BOARD OF COMMISSIONERS

AGENDA

Monday, April 27, 2015 - 6:30 PM

D. Resolution #2015-54 – ***Preliminary Approval*** – Preliminary Approval – Villanova University Housing Project

14. Sheet 7 of 30:

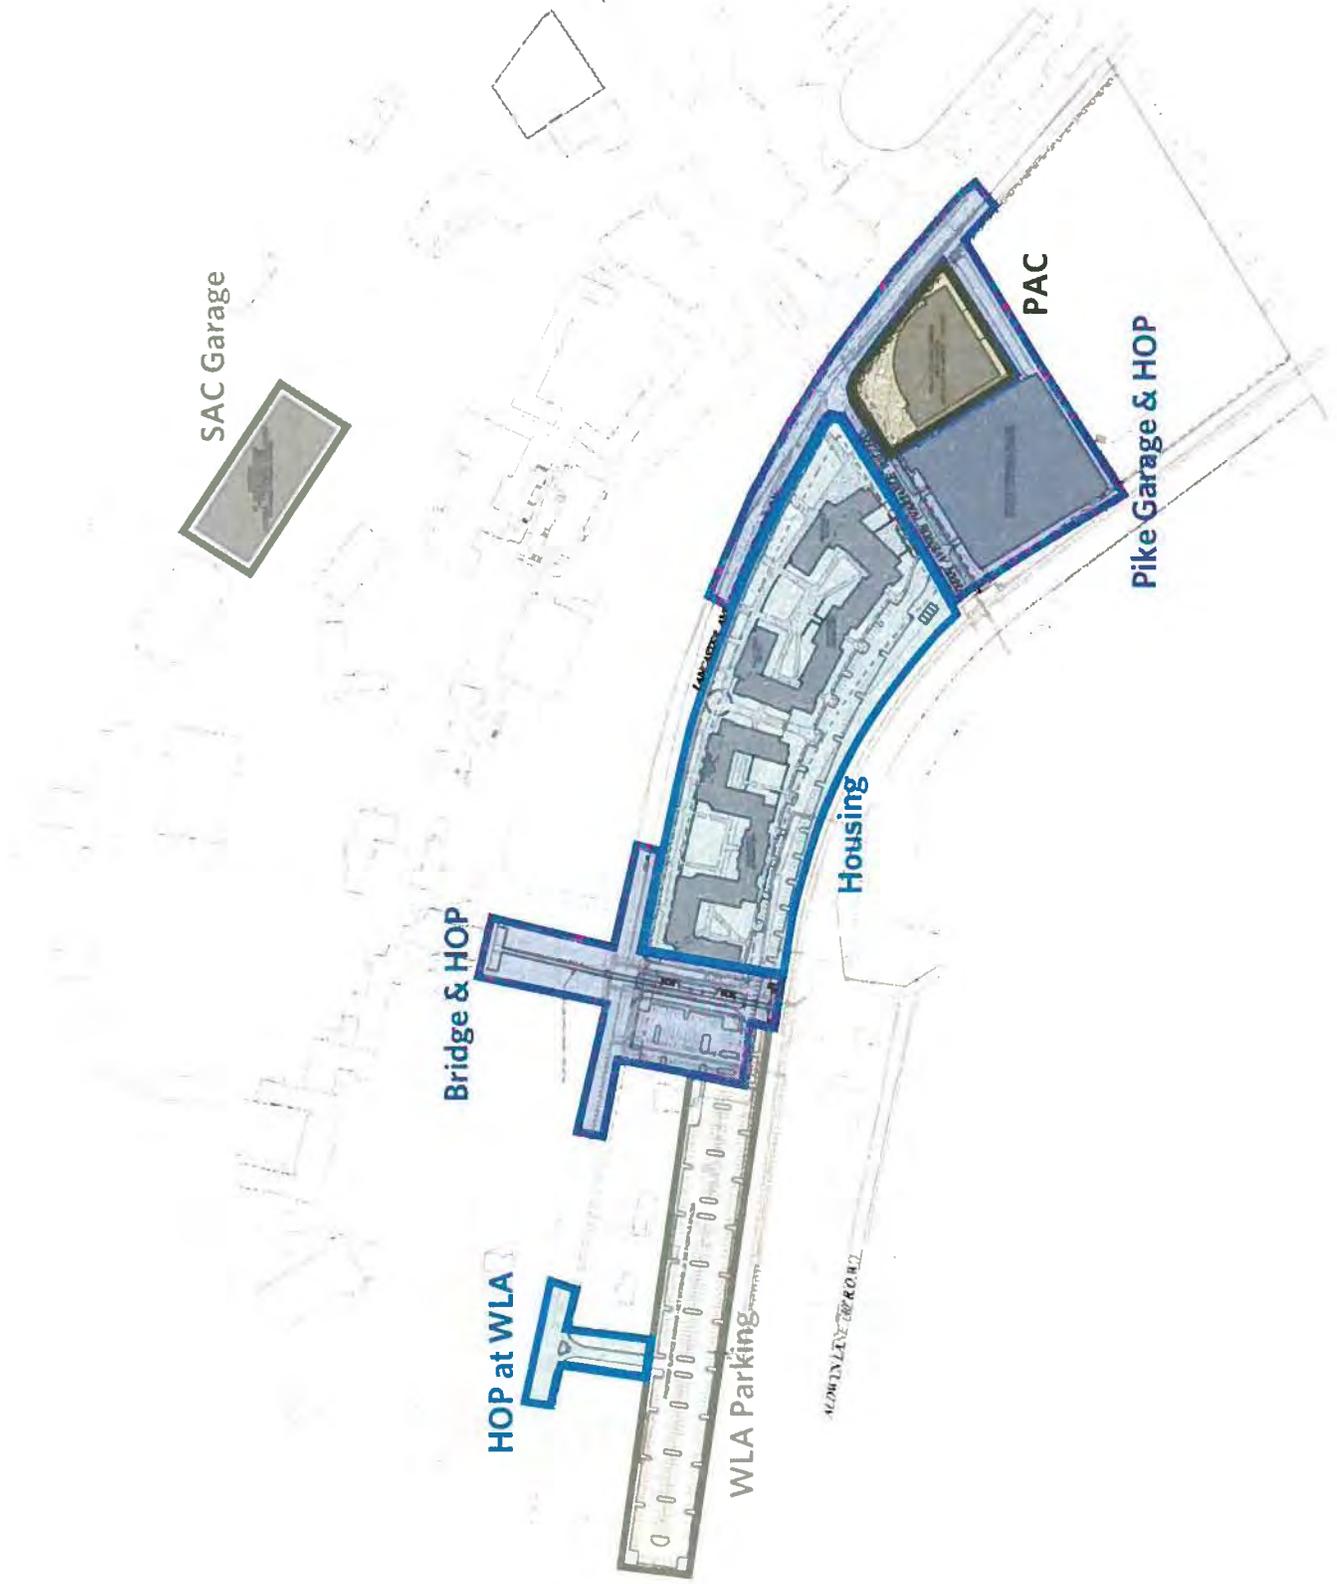
- i. Exhibit 1: the WB-50 right turn template must turn into the right most curb lane
- ii. Exhibit 2: Adjust the location of the eastbound stop bars to allow for the left turn movement from both exit lanes or include signage prohibiting trucks in the left most, left turn lane exiting Church Walks
- iii. Exhibit 4: Adjust the WB-50 turn template to eliminate the encroachment of the north-most eastbound through lane or increase the turn radius of the corner, as needed.
- iv. Exhibit 5: The exit movement must also be provided to determine if the WB-50 movement will encroach on parking spaces. If the exit movement will be through the signal at Church Walk, all internal site turns required to gain access to the intersection of Church Walk and Lancaster Avenue must be provided.

- v. Exhibit 7: The WB-50 truck template indicates the truck will encroach upon the southbound Ithan Avenue left turn lane at the Pike Lot garage. Revise to eliminate the encroachment or increase the northwest corner turn radius.
